Roundabout Traffic & Safety Assessment and Functional Design Review

Airport Road Environmental Assessment, King Street to
Huntsmill Drive

Prepared for Region of Peel
by IBI Group
August 9, 2019

A *Roundabout Functional Design Review – 1st Review draft* was completed on September 18, 2018 by John Bayley, P.Eng and Mr. Sergei Filippov, C.E.T. The design review provided observations, suggestions and comments on the functional aspects of each of the three roundabouts with inputs later incorporated into the designs, dated October 12 (refer to Exhibit 3-3, Exhibit 4-3, and Exhibit 5-3). Following the first review, *Roundabout Functional Design*

REVISED GEOMETRY
 AIRPORT ROAD AT
 CRANSTON DRIVE
 FASTEST PATH
 ROUNDABOUT REVIEW 2
 SCALE 1:500

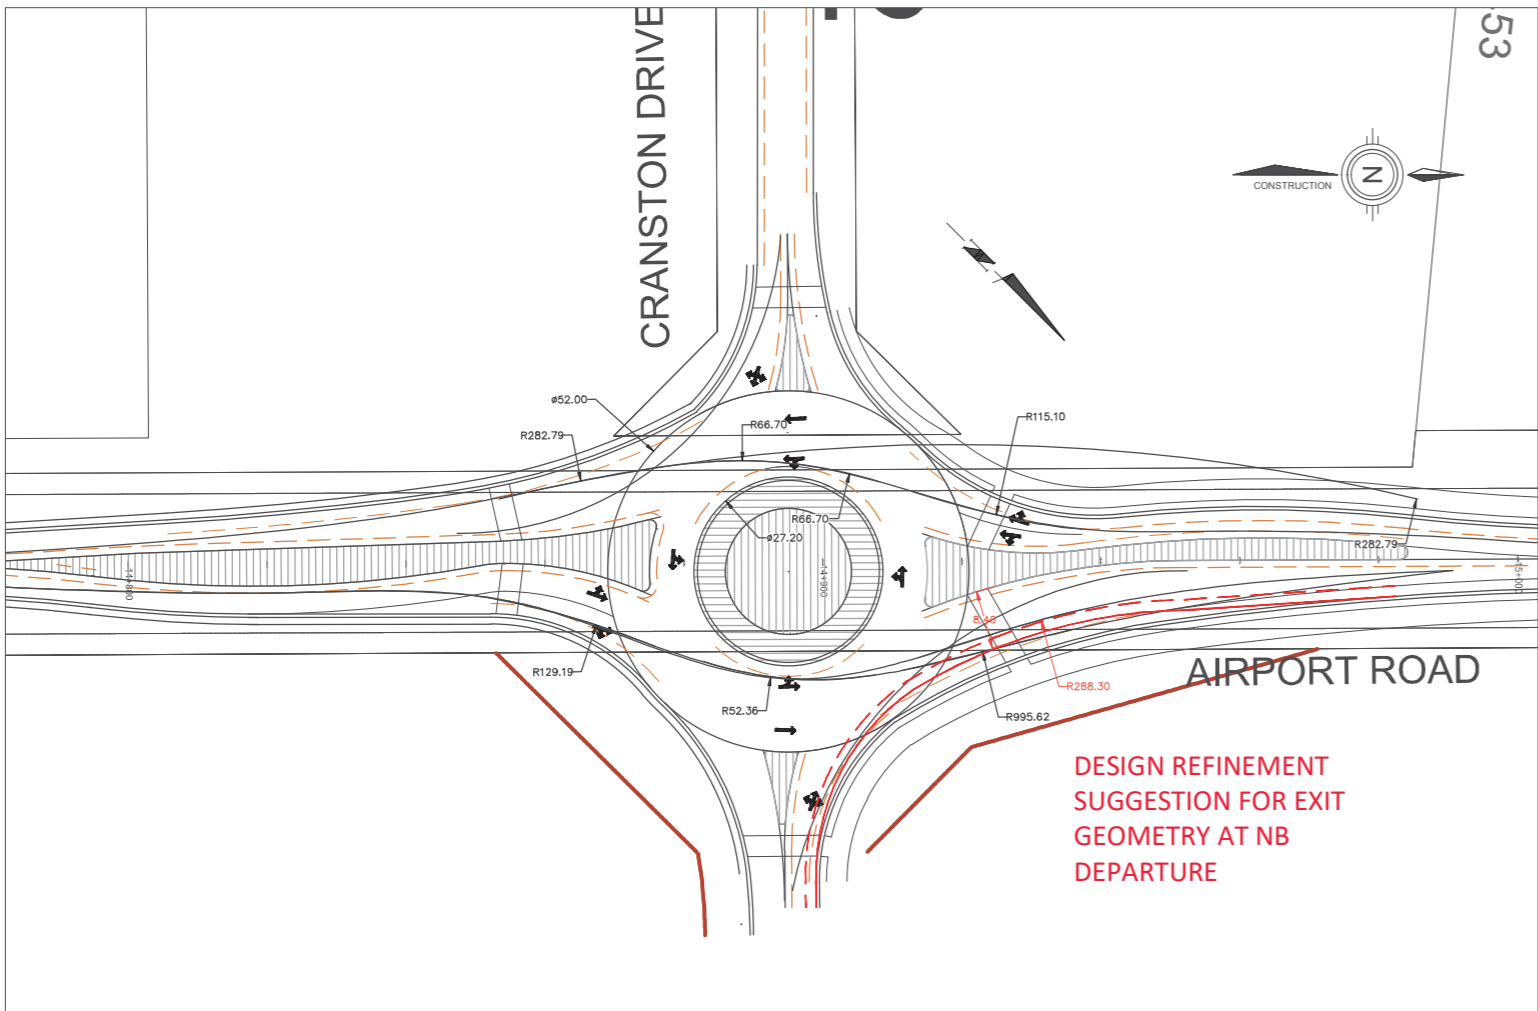
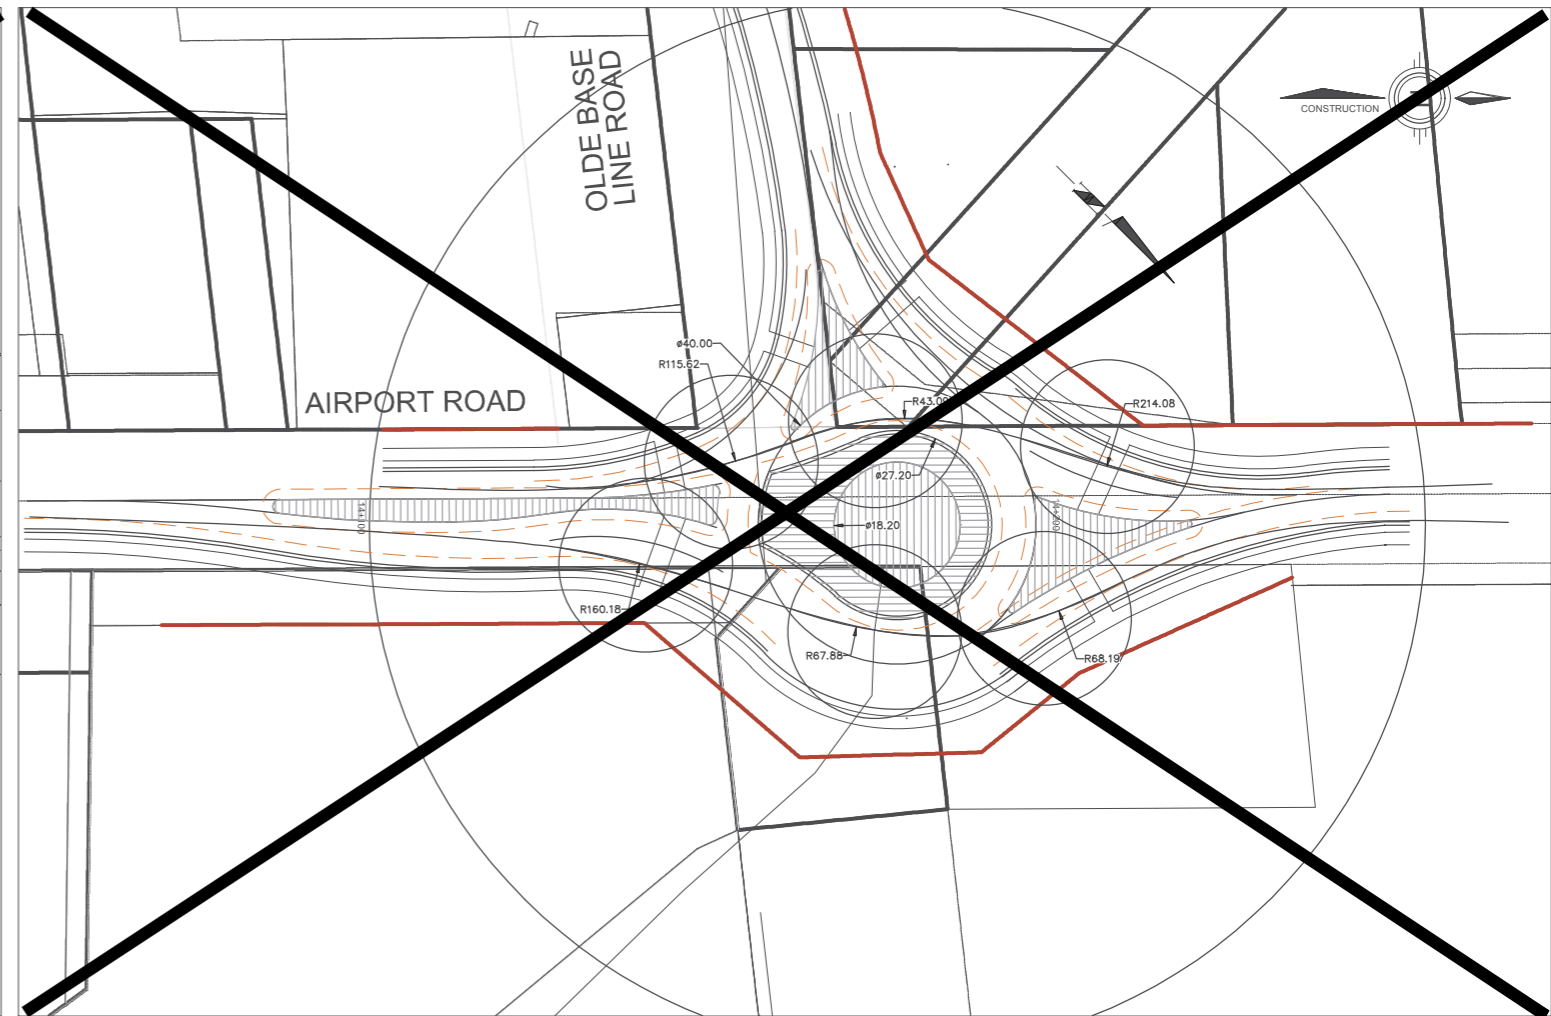
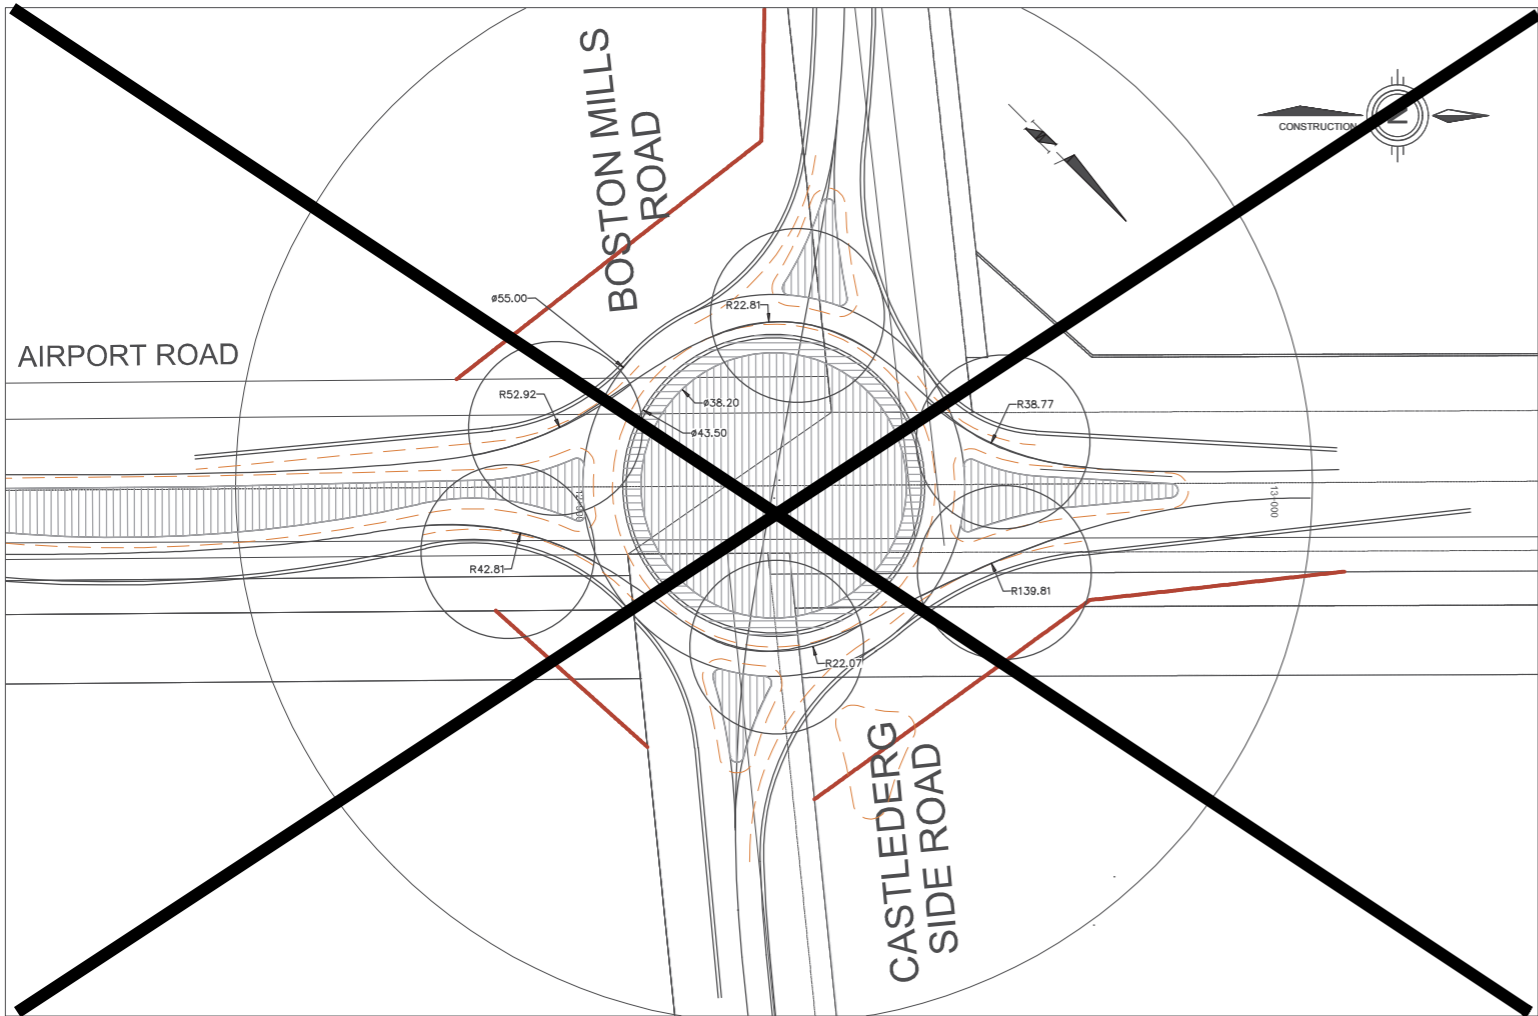
Swept Path Analysis: Preliminary review – WB-20 design vehicle – see attached Figure 3A.

Fastest Path - For the current design layout the SB fastest path speeds are approximately 49-40-68 km/hr (R1, R2 and R3) while NB fastest path speeds are approximately 51-37-109 km/hr and a worst case maximum speed of 38 km/h on right turn movements. The higher than desirable exit velocity for the NB fastest path (109 km/hr) should be refined to lower the speed in the area of the pedestrian crossing and as such we have included an example modification that will achieve lower exit velocity (69 km/hr) at the departure for the NB through movement (NE quadrant). Similar consideration should be given to the SB movement and further refined for the NB movement using both lane narrowing and possible ICD reduction combined with modified deflection of the departure geometries to further reduce the exit velocities.

Truck Turning – See Swept Path analyses in Figure 3A. The design appears to be acceptable to accommodate WB-20 truck movements.
